Silicon Anomaly List

ADSP-BF523/BF525/BF527(C)

ABOUT ADSP-BF523/BF525/BF527(C) SILICON ANOMALIES

NR003469K

71. 05000457 - Host DMA Port Responds to Certain Bus Activity Without HOST_CE Assertion:

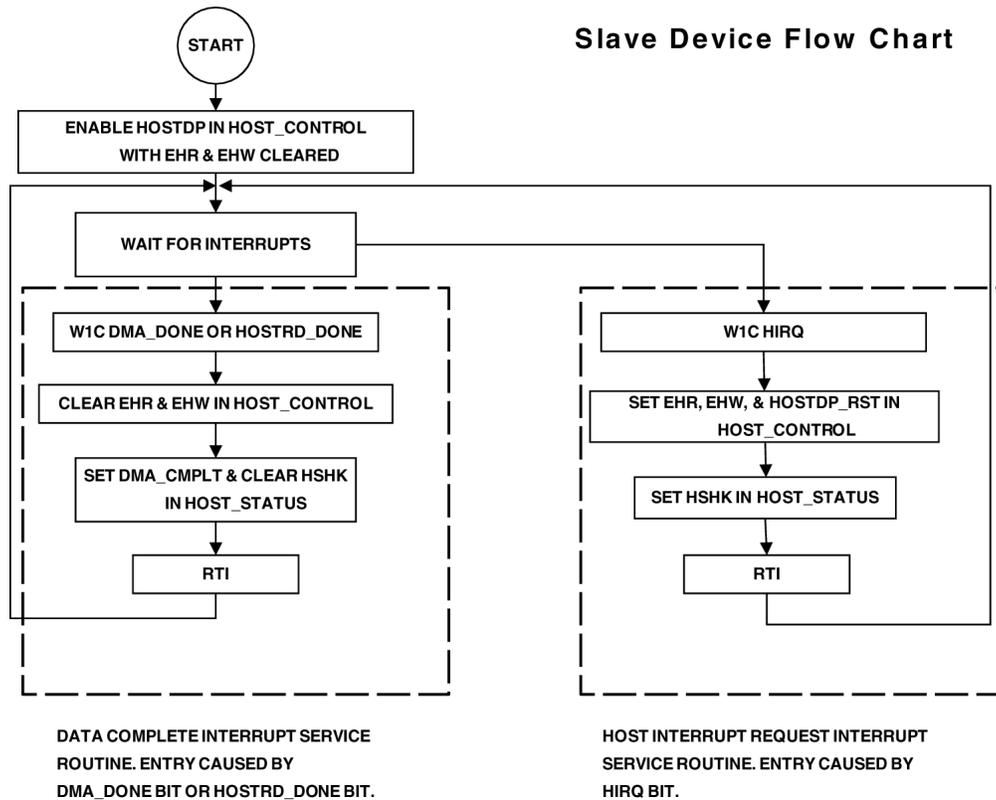
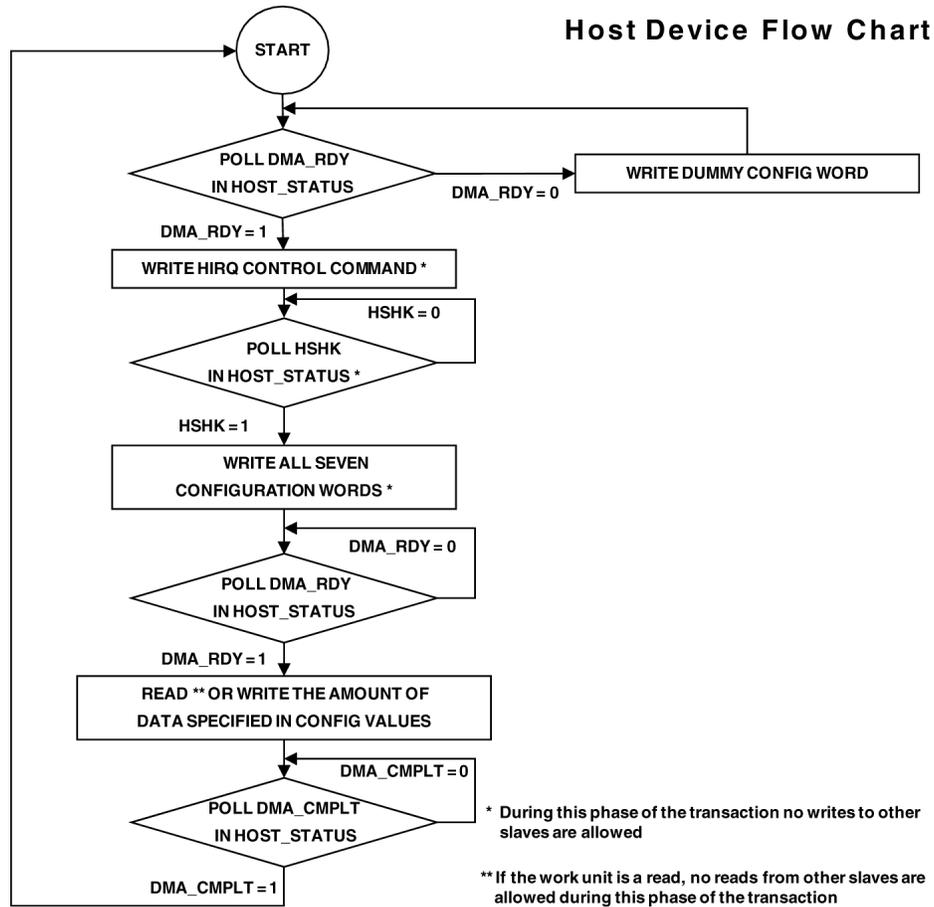
The Host DMA Port (HOSTDP) responds to certain bus activity even without the assertion of its chip enable, HOST_CE. If the HOSTDP is the only slave on the bus (meaning that HOST_WR and HOST_RD are asserted by the host only for communicating with the HOSTDP), this anomaly will not be observed. There are two states in which the HOSTDP responds to bus activity (assertion of HOST_WR or HOST_RD) without HOST_CE being asserted:

- 1) HOSTDP is Enabled and Waiting for the Host to Configure - While waiting for configuration in both acknowledge and interrupt modes, assertions of HOST_WR for other slaves can cause the HOSTDP to be erroneously configured.
- 2) HOSTDP is Configured for Data Reads - While waiting for data reads in both acknowledge and interrupt modes, assertions of HOST_RD for other slaves can cause the HOSTDP to subsequently return data out of order.

- 1) Add additional logic - Connect to HOST_WR through a 2-input OR gate where one input of the OR gate is the host's write signal and the other is the host's chip select.
- 2) Time bus accesses by the host processor - Do not write to other slaves on the bus between the time that the HOSTDP is enabled and the DMA_RDY bit in HOST_STATUS is set.
- 3) Change the software on both the host and the slave as shown in the following flowcharts:

- 1) Add additional logic - Connect to $\overline{\text{HOST_RD}}$ through a 2-input OR gate where one input of the OR gate is the host's read signal and the other is the host's chip select.
- 2) Time bus accesses by the host processor - Do not read from other slaves on the bus between the time that the final configuration word (YMODIFY) is written to the HOSTDP and the DMA_CMLPT bit in HOST_STATUS is set.
